**EUROPEAN CONNECTION CONDITIONS
(ECC)**

ECC.6.3.15 FAULT RIDE THROUGH

Draft

Figure ECC.6.3.15.9(a)

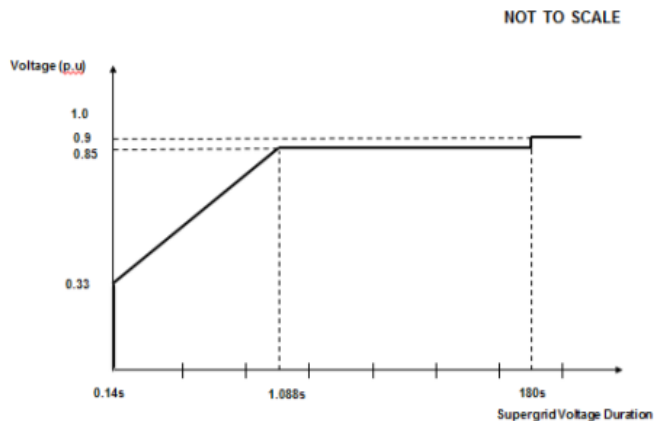
- (iv) For up to 30 minutes following such a **Supergrid Voltage** dip on the **Onshore Transmission System** each **Synchronous Power Generating Module** is required to remain connected and stable provided system operating conditions have returned within those specified in ECC.6.1.

Commented [A3]: Time period added

Commented [A4]: Scope widened

Figure ECC.6.3.15.9(b)

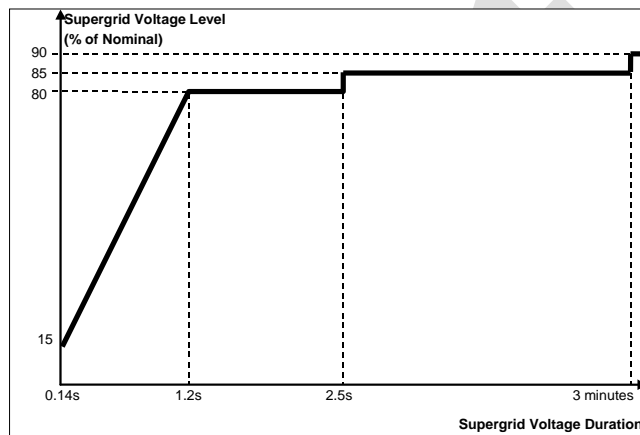
- (iv) For up to 30 minutes following such a Supergrid Voltage dip on the Onshore Transmission System each Power Park Module and OTSDUW Plant and Apparatus is required to remain connected and stable provided system operating conditions have returned within those specified in ECC.6.1.

Commented [A5]: Time period added

Commented [A6]: Scope widened
